THE MARYLAND-NATIONAL CAPITAL PARK AND PLANNING COMMISSION

**MEMORANDUM**

REVIEW TYPE: Preliminary Plan Review

PROJECT NAME: Bannockburn Heights

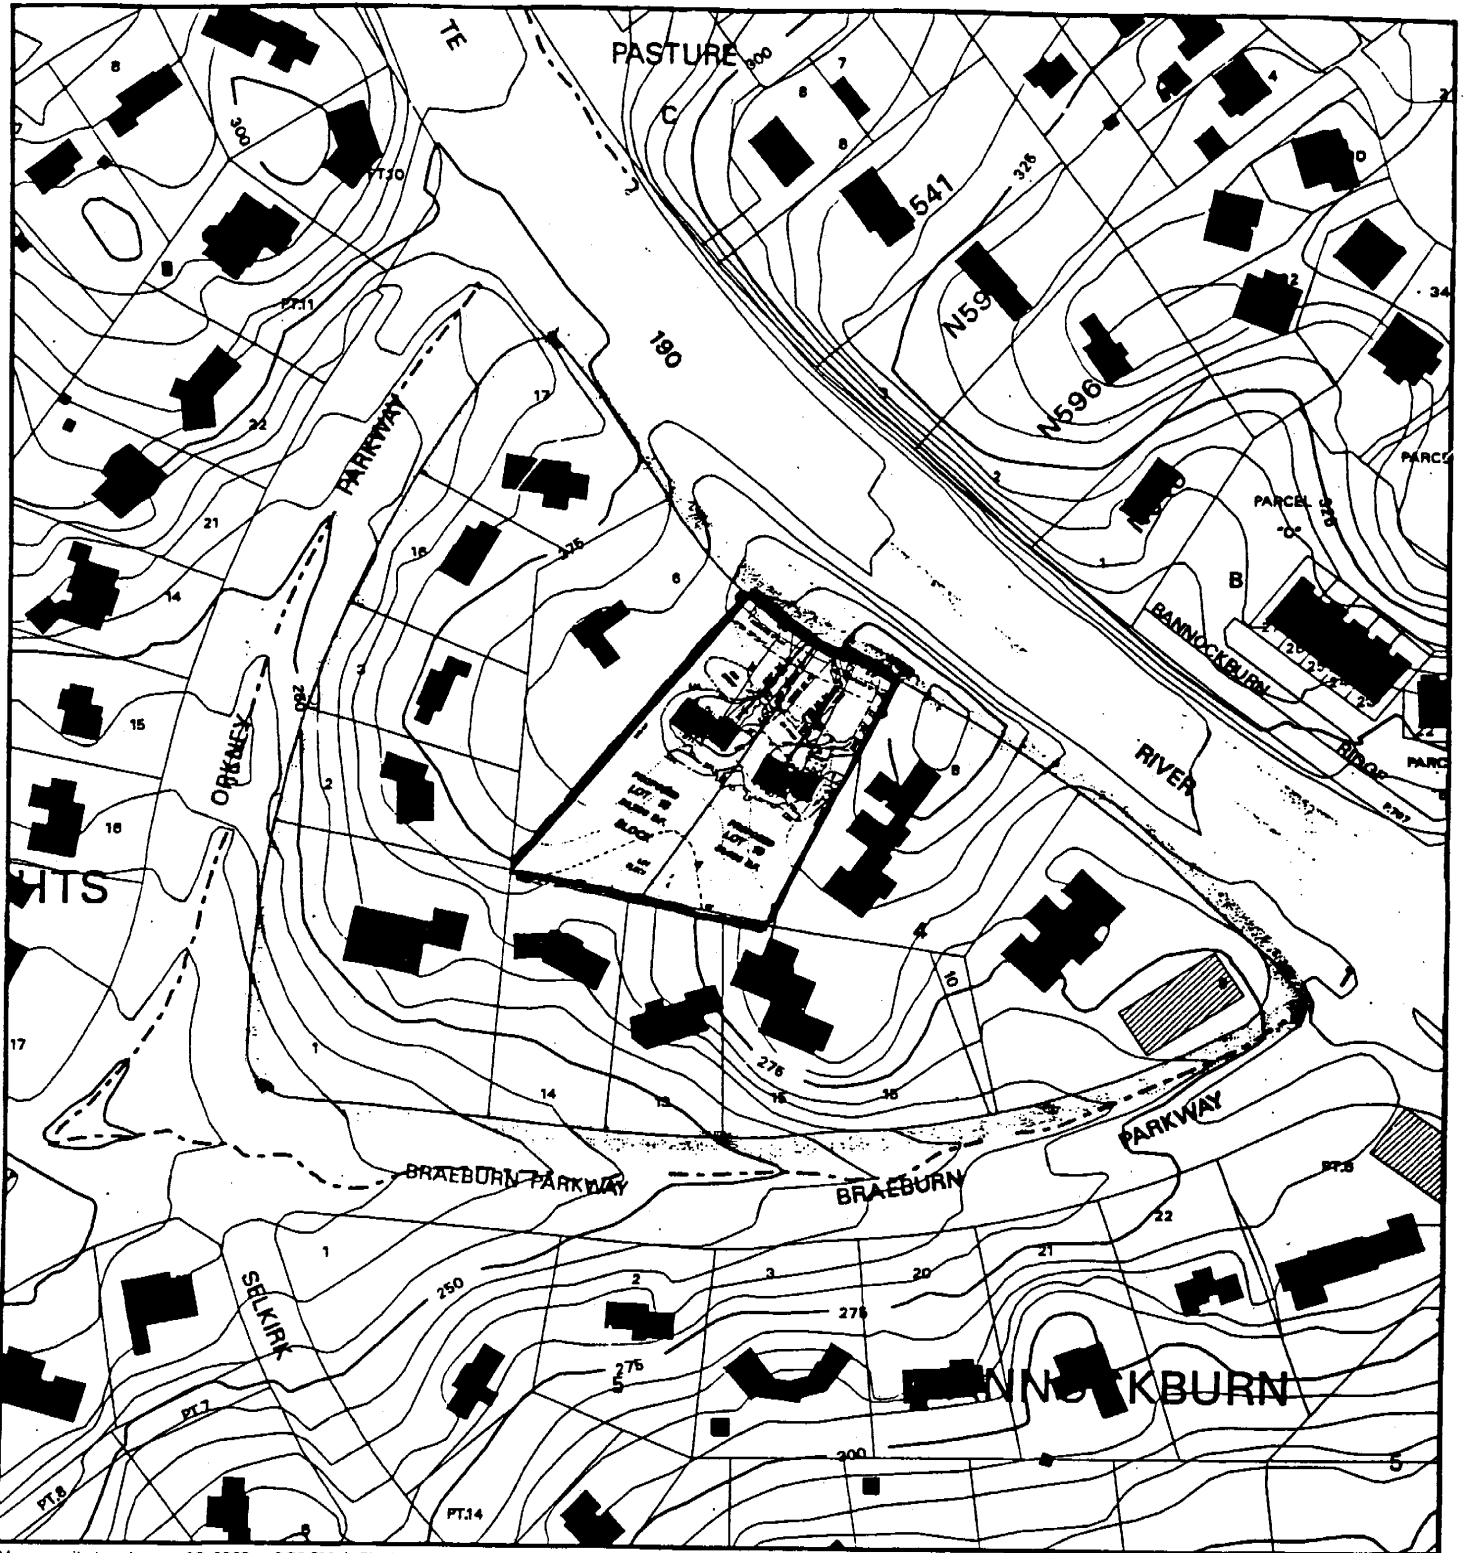
In applying the resubdivision criteria to the neighborhood delineated by staff, staff finds that the proposed resubdivision does not comply with all seven of the criteria set forth in Section 50-29(b)(2) as illustrated by the characteristics set forth on the attached tabular summary. Staff finds that a high correlation does not exist between the frontage and widths of the proposed lots and existing lots within the delineated neighborhood.

As the tabular summary depicts the smallest lot frontages found in the defined neighborhood are those of the proposed lots. Indicative of smaller lot frontages are the smaller lot widths. As in this proposal, the proposed lots widths are amongst the smallest within the defined neighborhood.

The application, as proposed, clearly fails when applying the resubdivision criteria. Staff finds that the frontage and width of the proposed lots do not have a high correlation to those criteria of existing lots in the delineated neighborhood and therefore recommend disapproval of this proposed resubdivision.
